## **BUILDING CODE OF AUSTRALIA ASSESSMENT**

**I-MED Radiology Brookvale**  
660-664 Pittwater Road,  
Brookvale NSW 2100  
Lot 1 on DP877292

**Date:** 11<sup>th</sup> July 2024  
**Prepared for:** Y-Squared Pty Ltd

McKenzie Group (NSW) Pty Ltd have been engaged by Y-Squared Pty Ltd to undertake a Building Code of Australia Review of the existing tenancy for a proposed [medical centre](#) fit-out for I-MED Radiology Network - Brookvale, with consideration of the *State Environmental Planning Policy (Exempt and Complying Codes) 2008 (note 1) and BCA*.

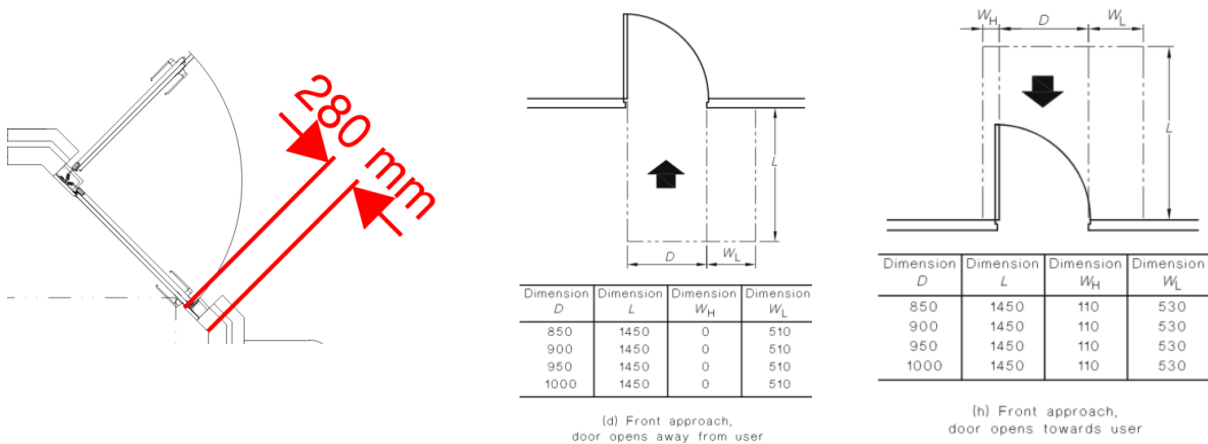
Following the review of the plans provided it can be confirmed that the proposed fit-out plans indicate that compliance with the provisions of BCA Part D4 generally appear to be achieved.

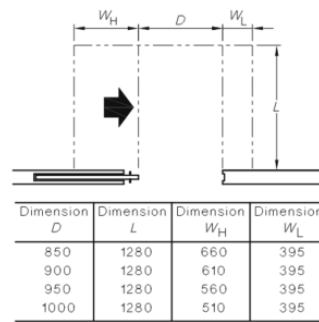
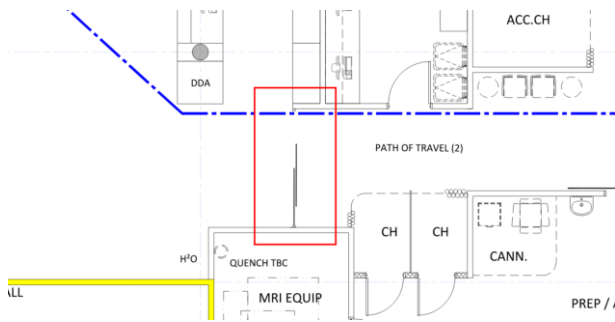
- The door circulation spaces provided to the MRI Room within Tenancy T1 does not achieve compliance with AS1428.1-2009 as a latchside clearance of not less than 530mm on approach and/or 510mm upon exit from the room does not appear to be provided:

(a) Slide-side approach

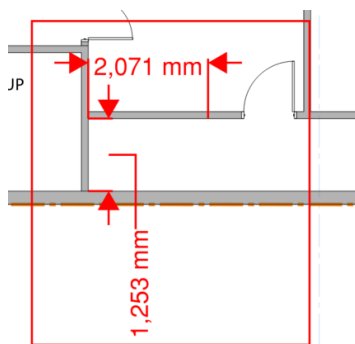
- The sliding door providing access through the centre of Tenancy T1 does not appear to be provided with sliding door circulation spaces in accordance with AS1428.1-2009 – [Following the confirmation received: 09/07/2024 – Y Squared Pty Ltd – It is acknowledged that this sliding door is proposed as being a power operated door; therefore, compliance appear to be demonstrated.](#)
